Re: Soil Conditions and Foundations,  
Proposed C.P.R. Underpass,  
Highway #15 & #7,  
Ottawa, Ontario. W.P. 907-64

T7625  
REPORT  
TO  
DEPARTMENT OF HIGHWAYS, ONTARIO  
ON  
SOIL CONDITIONS AND FOUNDATIONS  
PROPOSED C.P.R. UNDERPASS  
HIGHWAYS #15 & #7  
OTTAWA ONTARIO

C.P.R. Subway at Hwy. 7 & 15,  
3.2 Miles West of Ottawa,  
District #9 -- W.P. 907-64.  
(Report by Geocon, Limited,  
Consulting Engineers).

We have reviewed the Preliminary Drawings D-5526-P9 and P-10 for the above-mentioned structure, and submit the following comments:

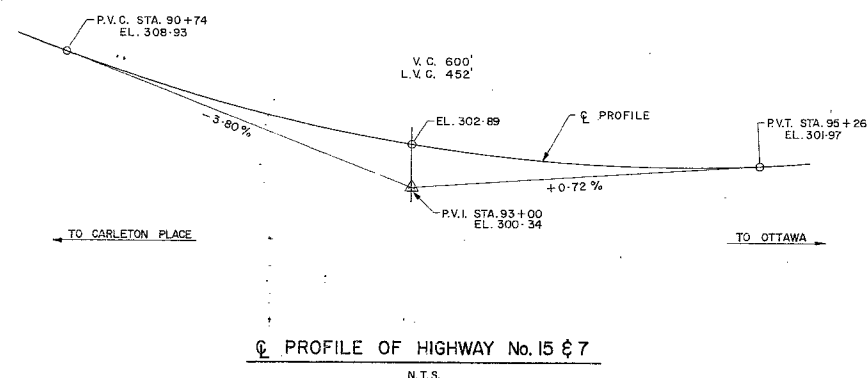
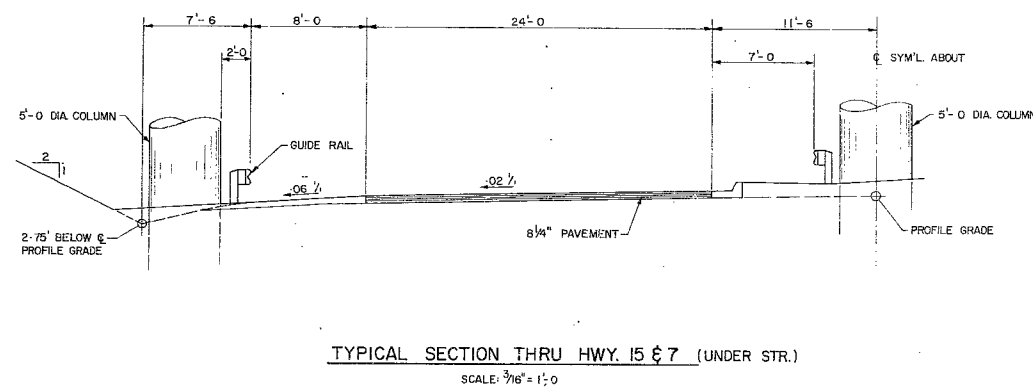
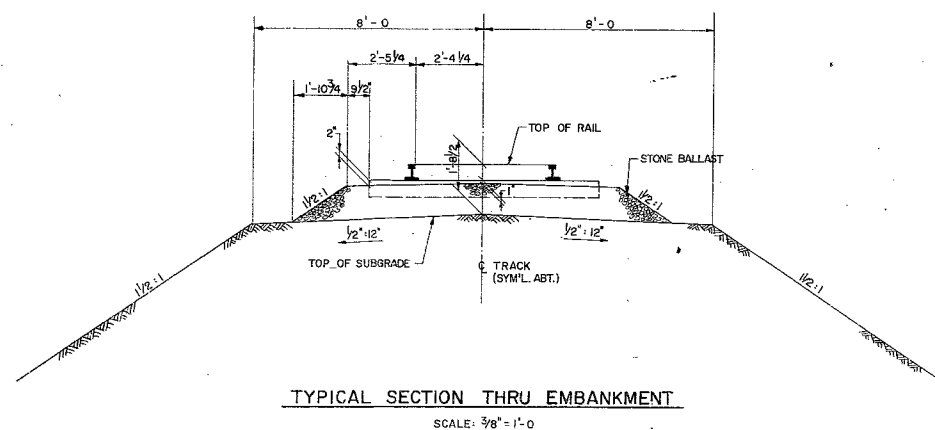
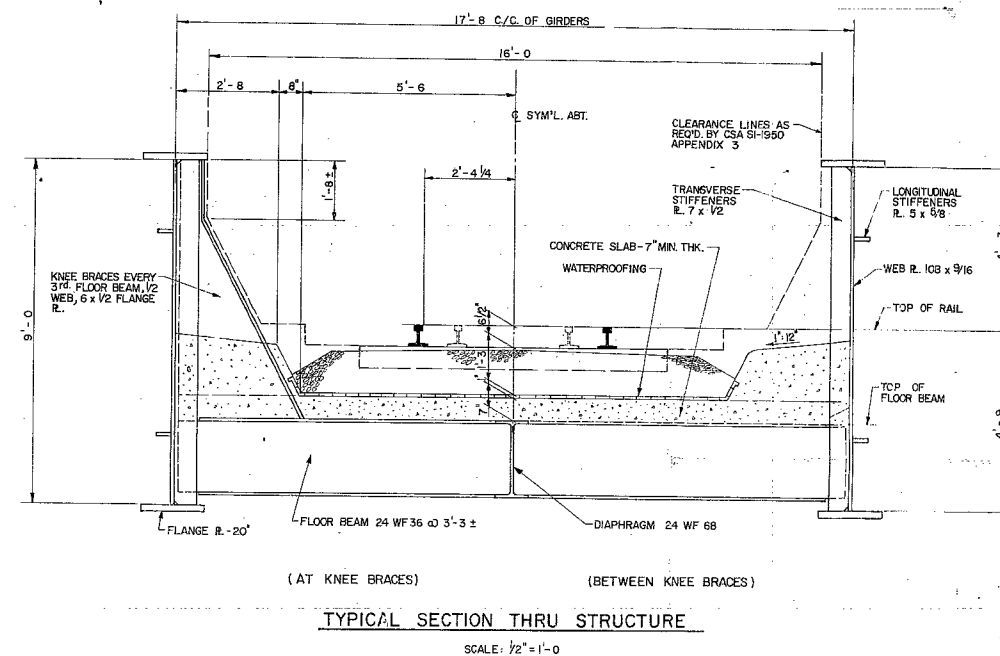
We would like to point out that the Drawing shows 1½:1 side slopes for the Railway approach fill embankment, whereas the Foundation Report by Geocon recommends 2:1 side slopes for all the approach fill embankments. The Foundation Report also indicates that the existing side slopes of the approach embankments of the Railway are 2:1.

With reference to Mr. Stermac's letter of December 29th,  $1\frac{1}{2}$ :1 side slopes for the Railway approach fill embankment was used adjacent to the structure in the preliminary design to reduce the extreme length of wing walls required for the closed abutment schemes. This was based on the fact that actual topo records showed an existing slope of about 1.6:1 and not 2:1 as shown in the Soils Report.

However, for the 4 span open abutment schemes a 2:1 slope was used to provide sufficient tail down span without uplift. As this type was finally adopted, we have used 2:1 slopes throughout in the final drawings modifying the stub abutments to suit.

In view of this no modifications to the final design drawings are required.
